SUBJECT: Addendum 2
A New Baseball Field for Worth County High School
Worth County School District

**A NEW BASEBALL FIELD
FOR WORTH COUNTY HIGH SCHOOL
WORTH COUNTY SCHOOL DISTRICT
ADDENDUM NO. 2
May 10, 2022**

E1002

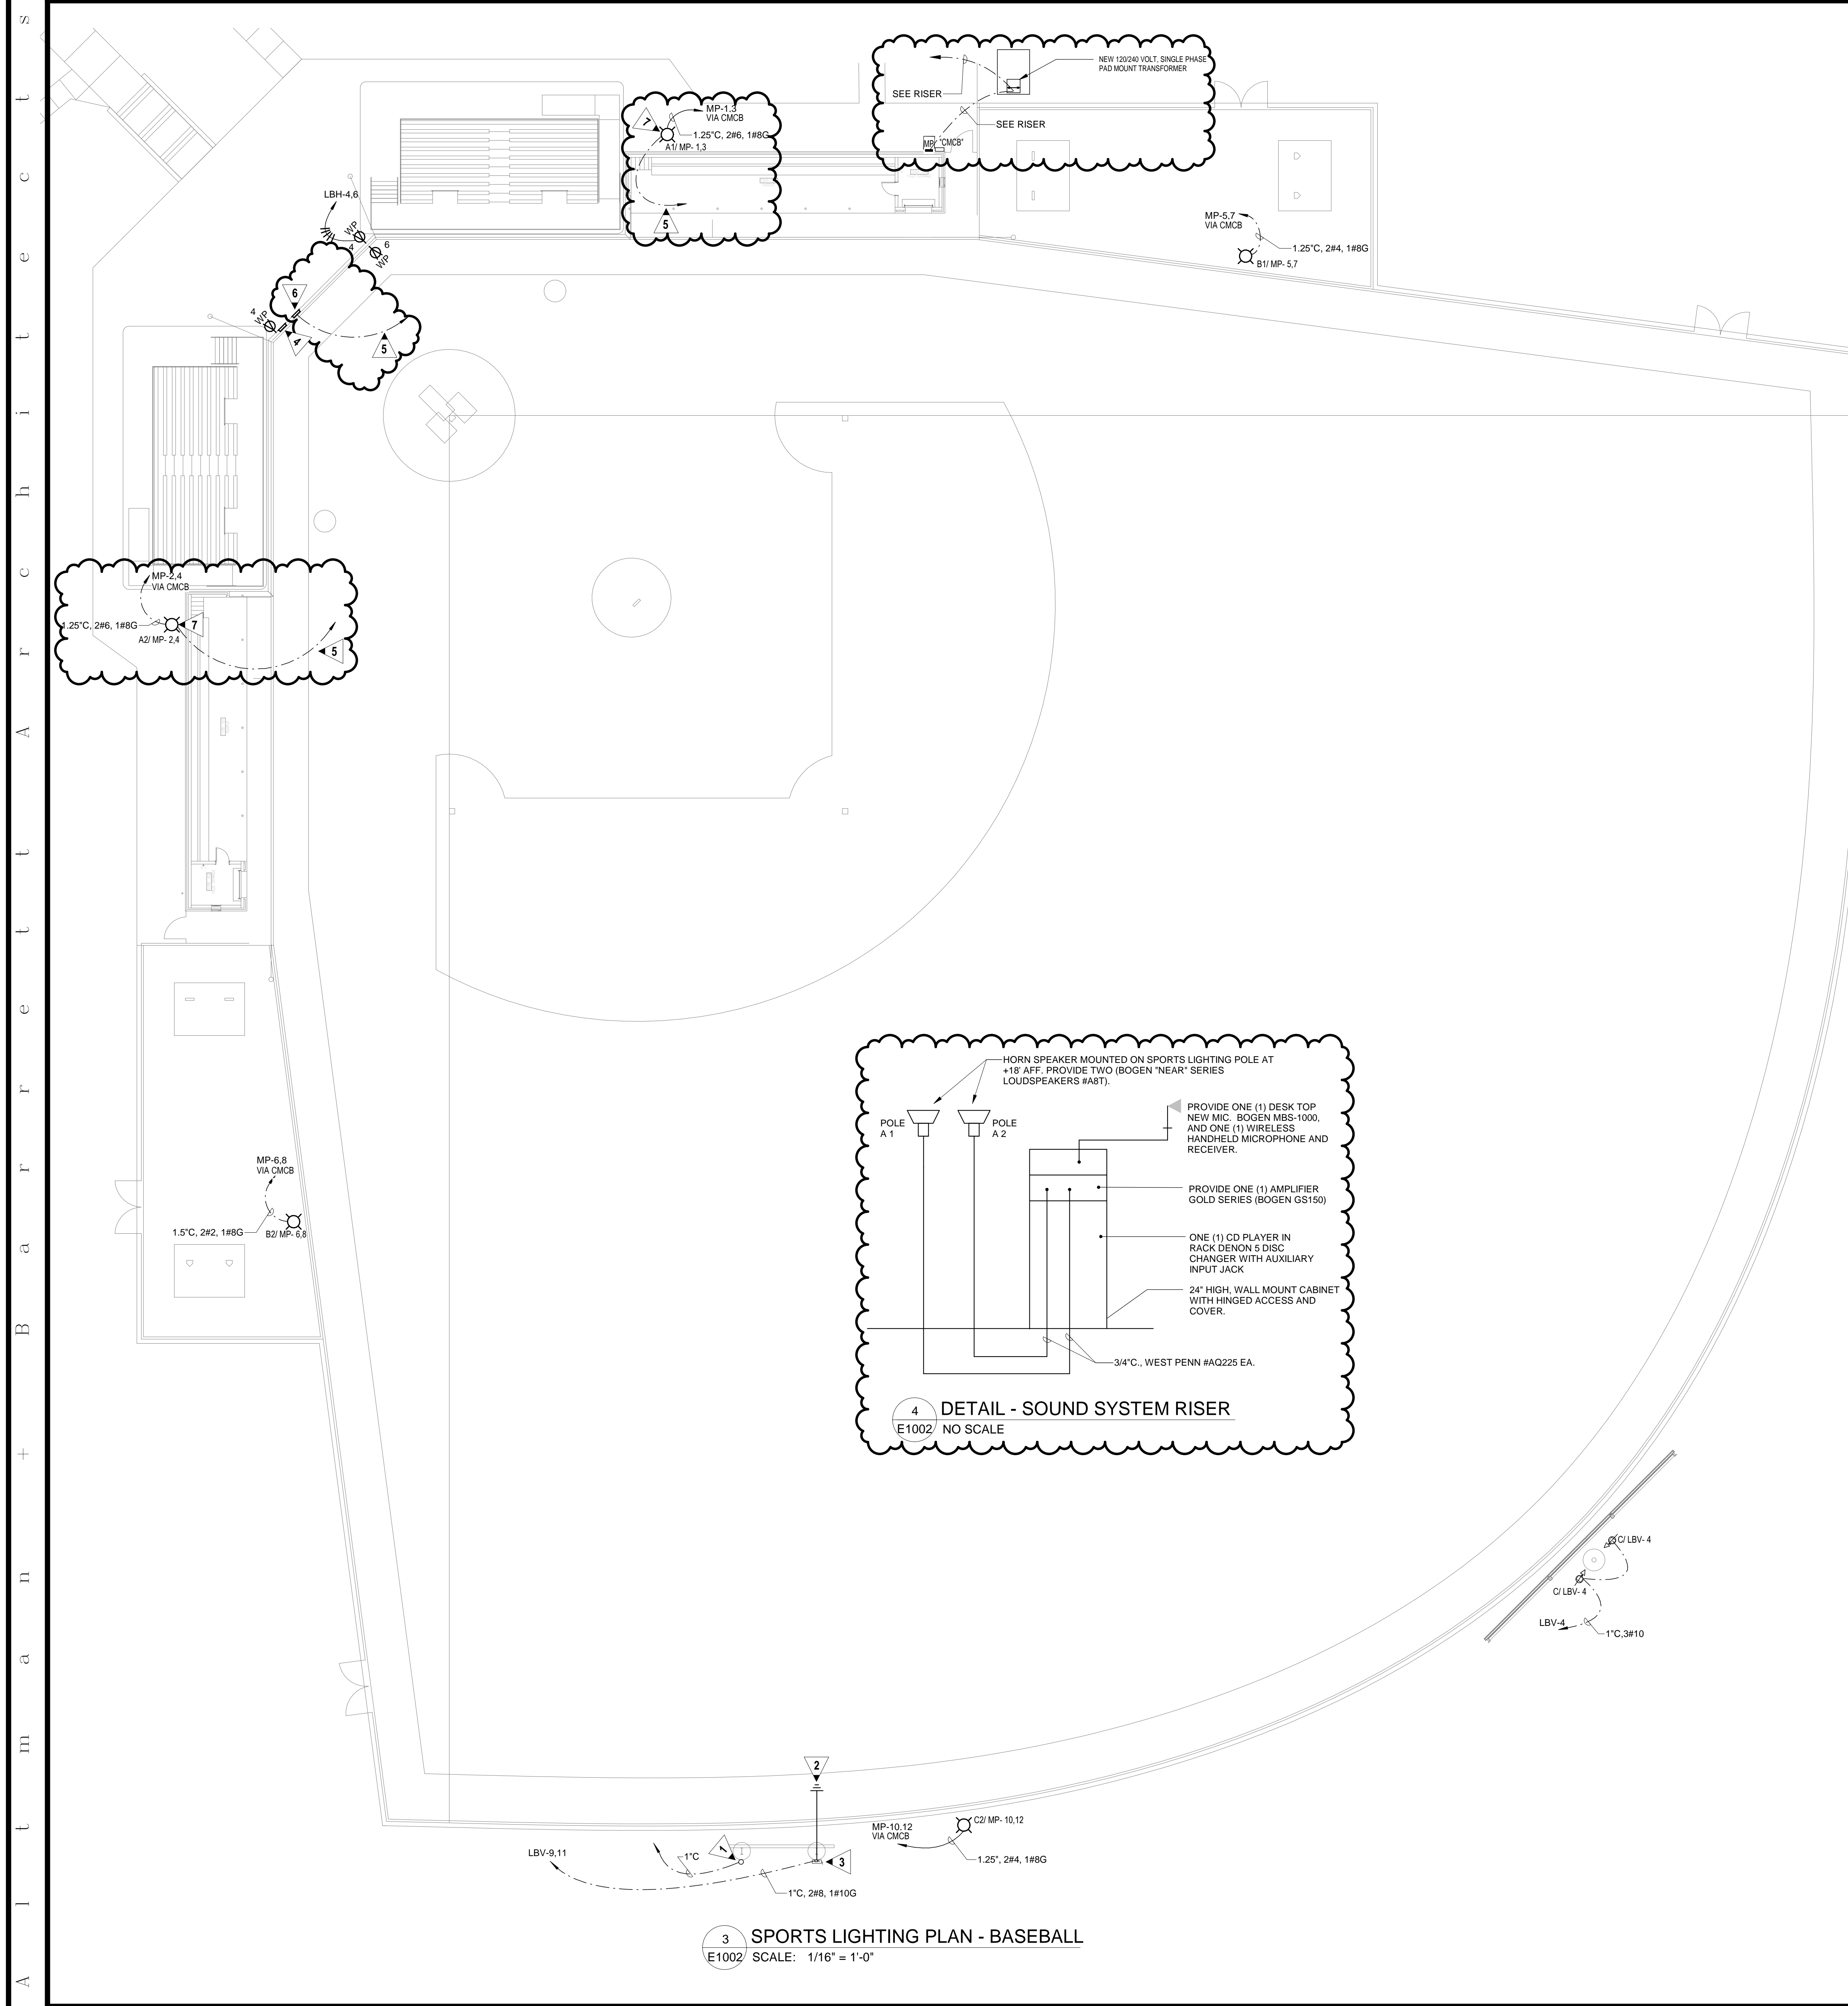
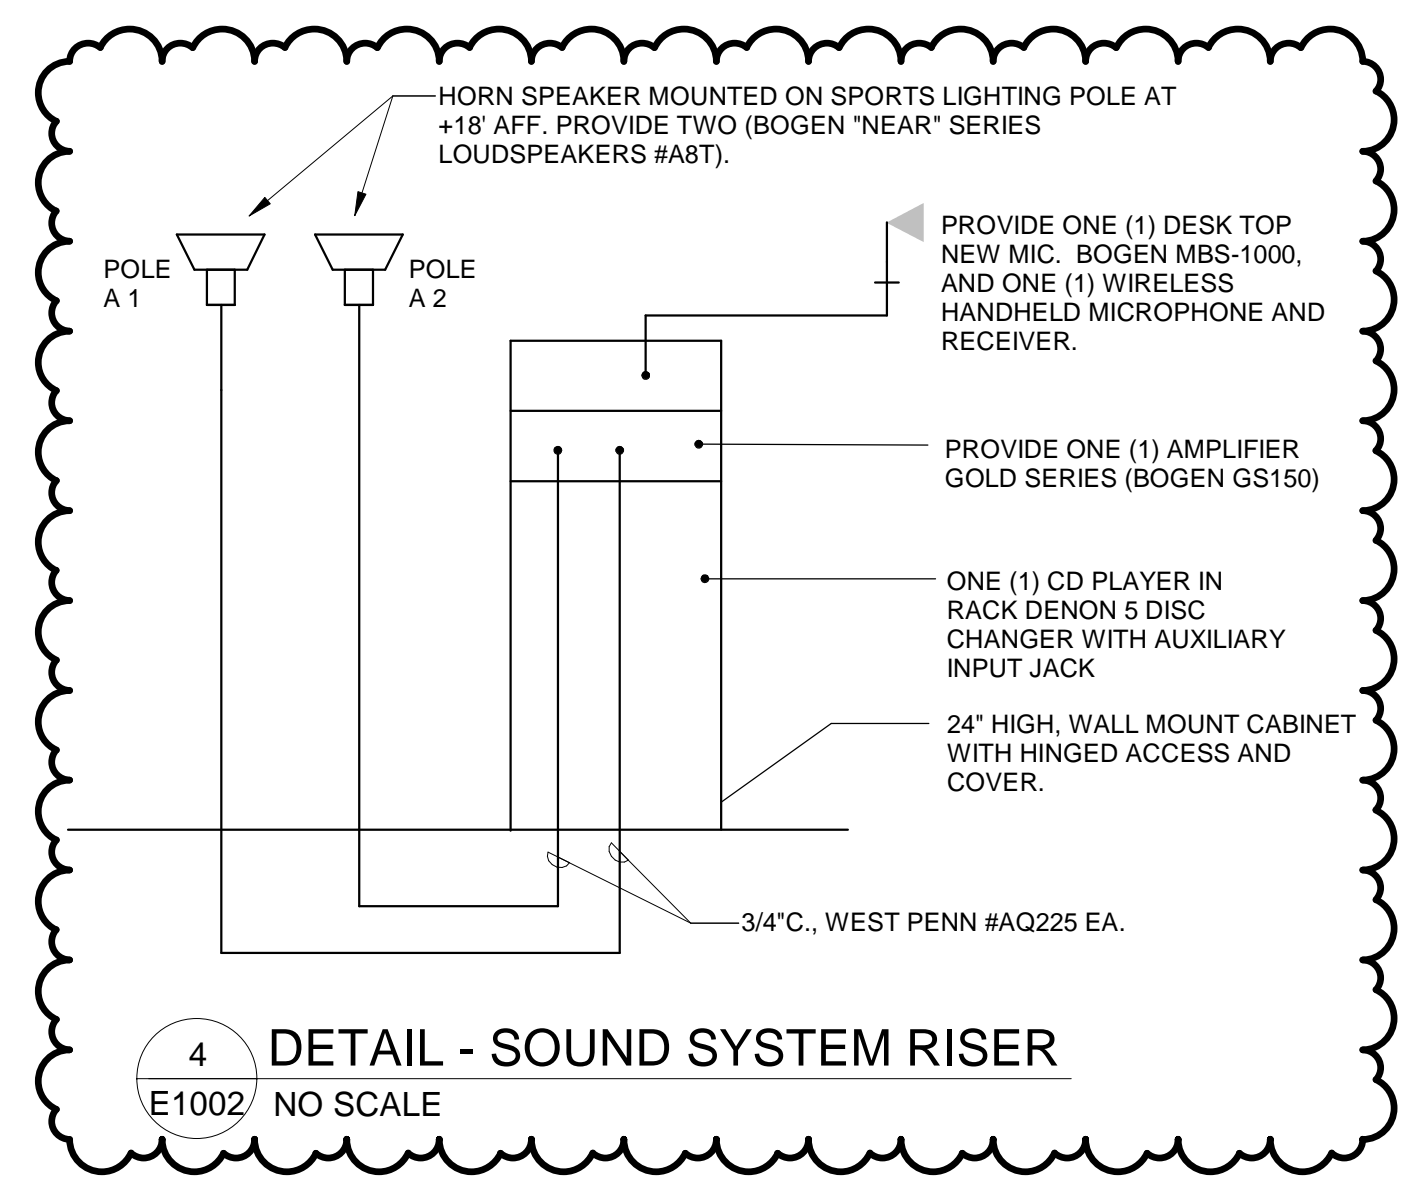
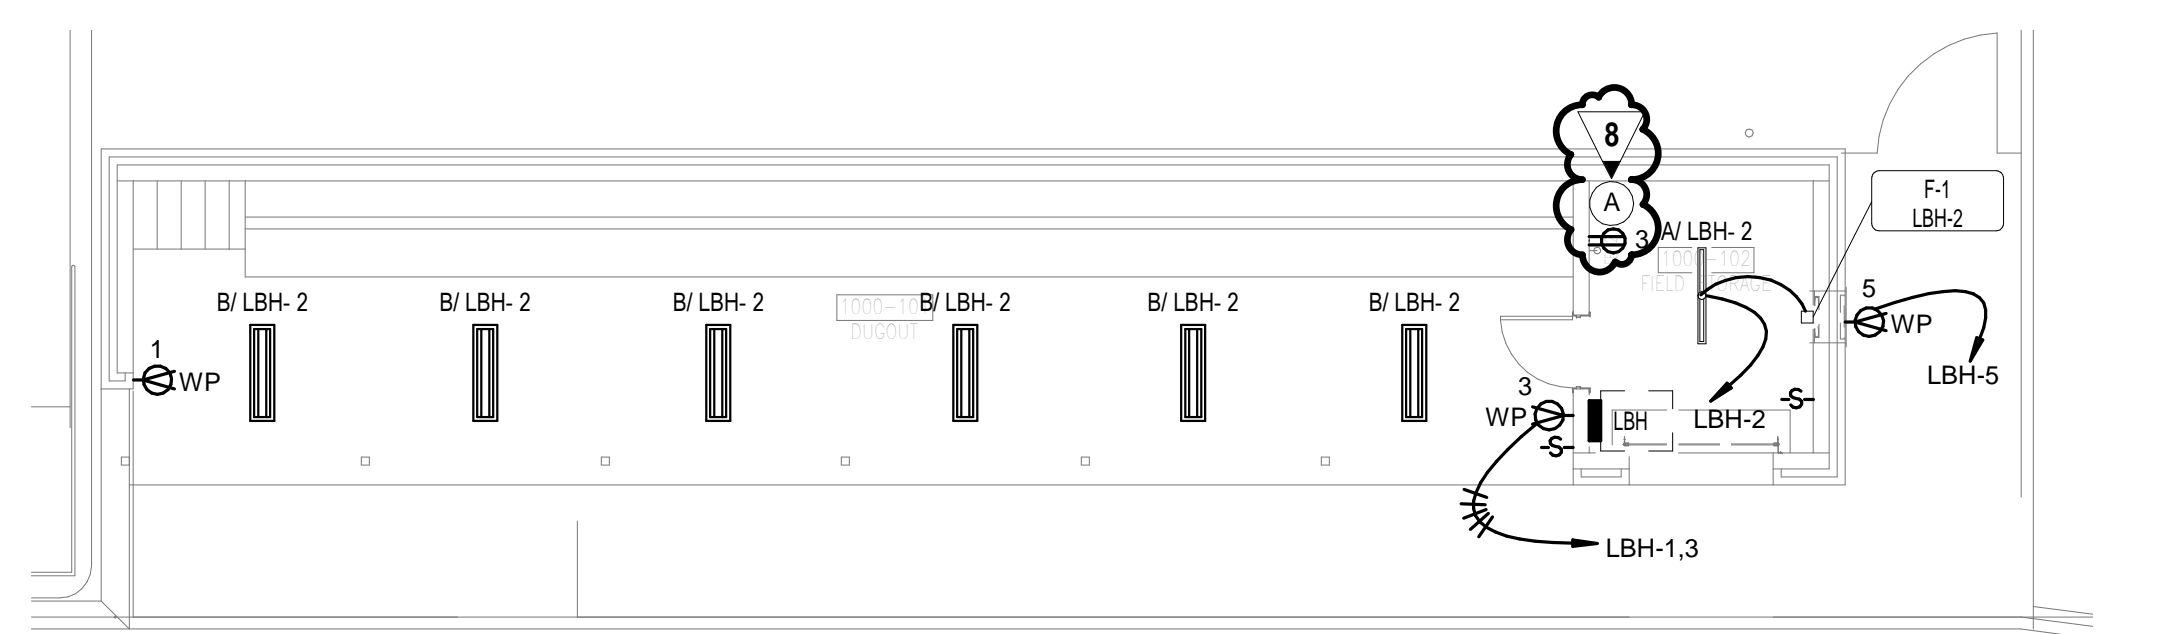
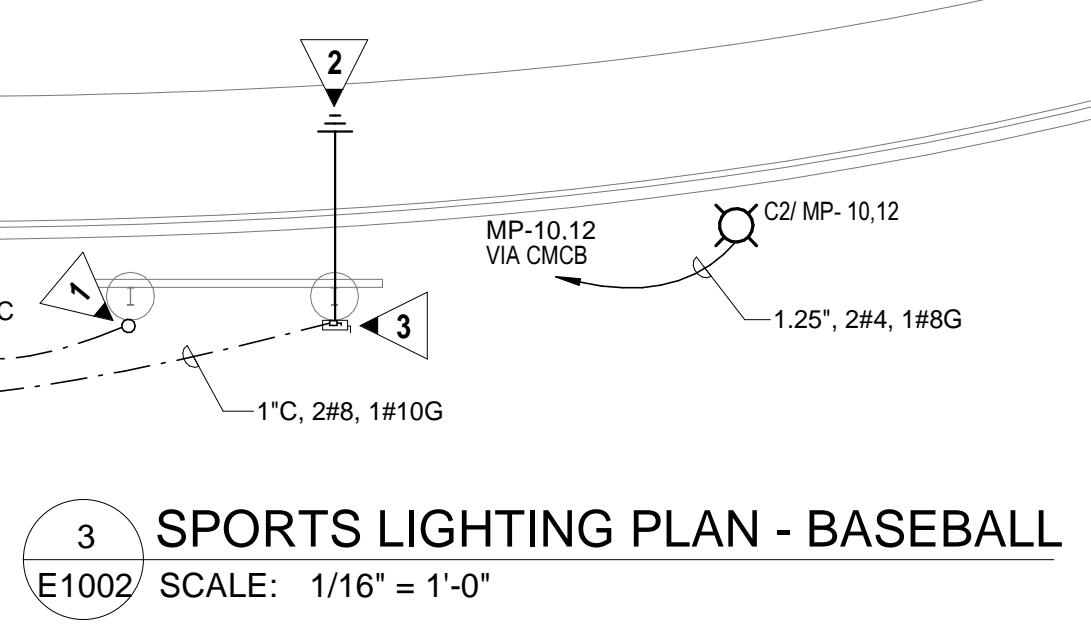
6. Sheet A2000:
 - a. Field Plan Baseball:
 - i. Add the following note at each location where drawing indicates (2) 6' WIDE GATES; COORDINATE EXACT GATE LOCATION WITH ARCHITECT AND OWNER PRIOR TO INSTALLATION.
7. Sheet E1001:
 - a. Add the attached Sheet E1001 in its entirety which adds the required work for electrical service.
8. Sheet E1002:
 - a. Delete Sheet E1002 in its entirety and replace with the attached Sheet E1002 which shows clouded changes for the electrical service and adds requirements for the sound system.

- KEYED NOTES:**
1. ROUTE 1" CONDUIT TO J-BOX BEHIND HOME PLATE (SEE KEYNOTE #4) FOR SCOREBOARD CONTROLS.
 2. PROVIDE 3/4" C, 1#6 GROUND AND CONNECT GROUND ROD TO POLE OF SCOREBOARD. PROVIDE BOND BUSHINGS AND GROUND LUGS AS REQUIRED TO GROUND POLE TO GROUND ROD. PROVIDE 3/4" X 10' COPPER CLAD GROUND ROD.
 3. 3022/R TO POWER SCOREBOARD. LOCATE AT BASE OF POLE. ALL EXPOSED CONDUIT SHALL BE GRG.
 4. FLUSHED RECESSE J-BOX IN WALL FOR SCOREBOARD CONTROL.
 5. 3/4" CONDUIT TO SOUND RACK IN BUILDING 1000-102.
 6. MICROPHONE OUTLET IN "WP" ENCLOSURE. SEE 4/E1002.
 7. MOUNT SPEAKER AT +18" ABOVE GRADE ON SPORTSLIGHT POLE. AIM TOWARD GUEST BLEACHERS. COORDINATE MOUNTING WITH POLE INSTALLER.
 8. PROVIDE WALL MOUNTED SOUND RACK. SEE DETAIL 4/E1002. POWER FROM RECEPTACLE CIRCUIT #3.

1 POWER RISER DIAGRAM - BASEBALL
 E2000 NO SCALE

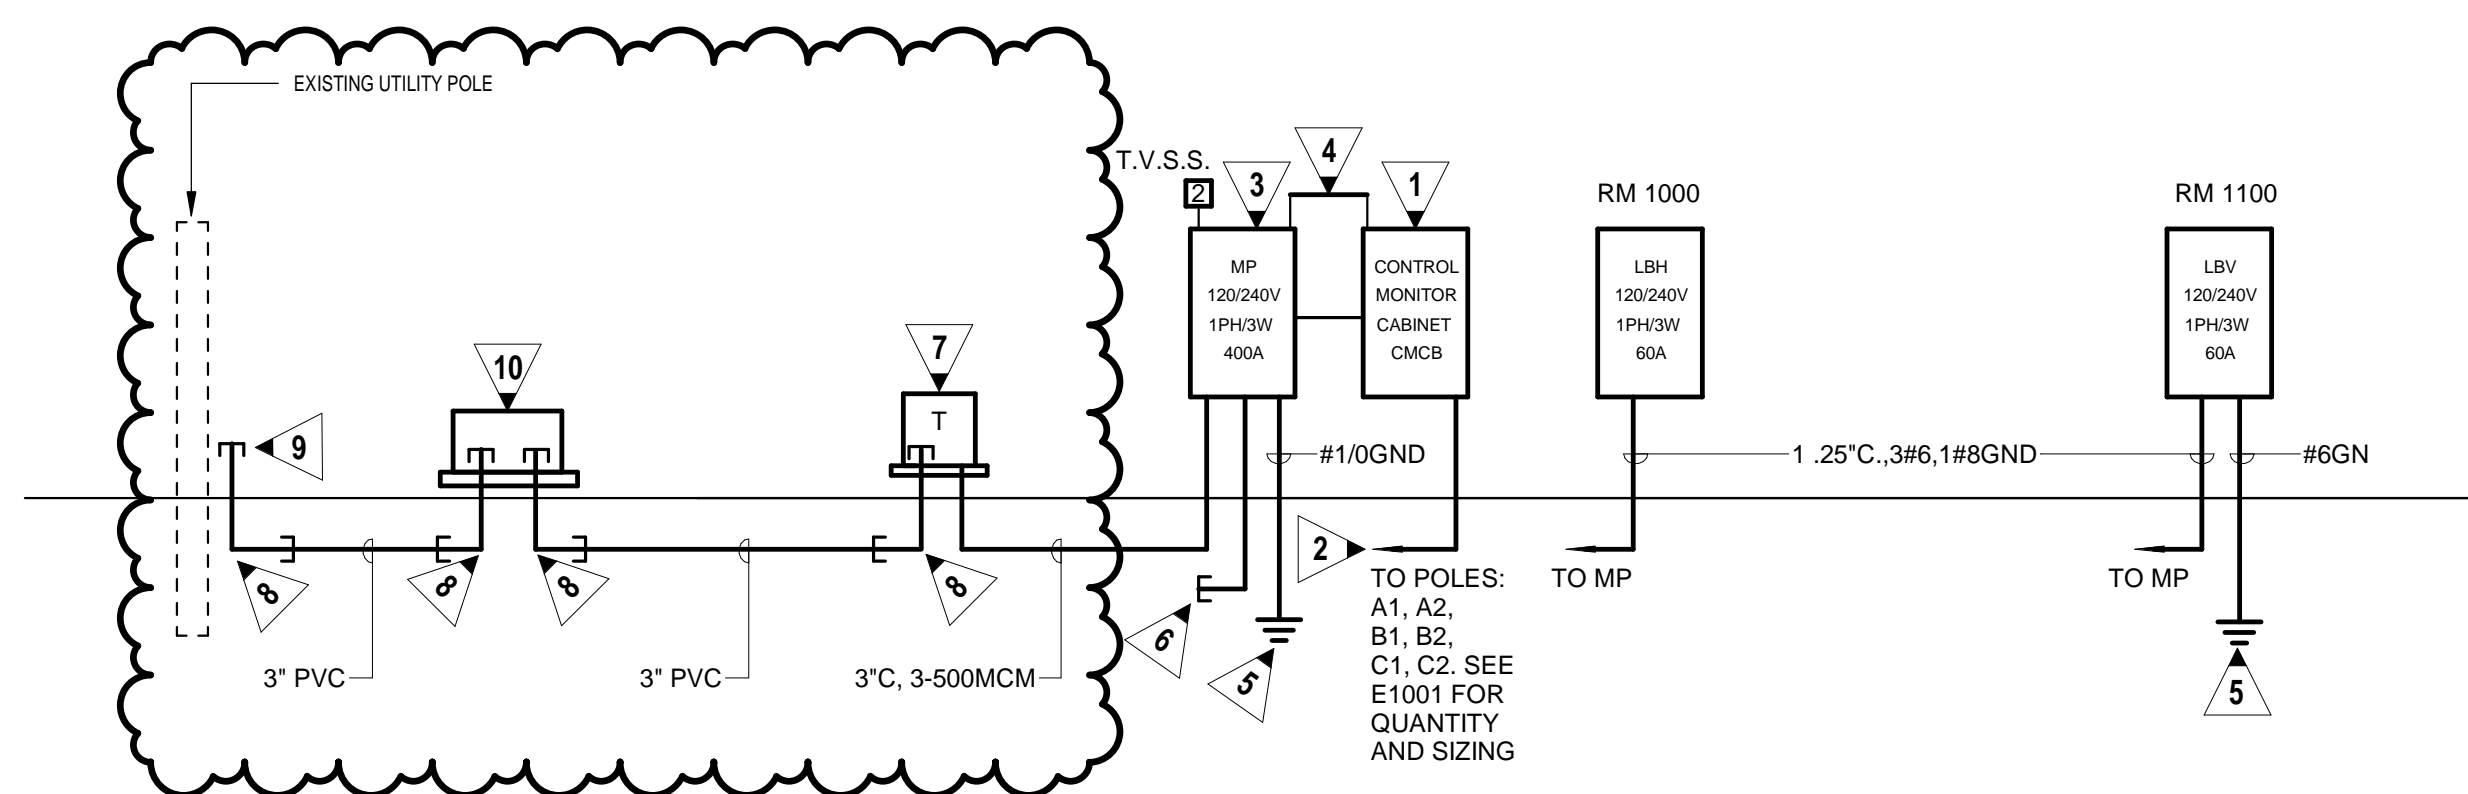
9. Sheet E2000:
 - a. Delete Sheet E2000 in its entirety and replace with the attached Sheet E2000 which shows clouded changes for the power riser diagram.
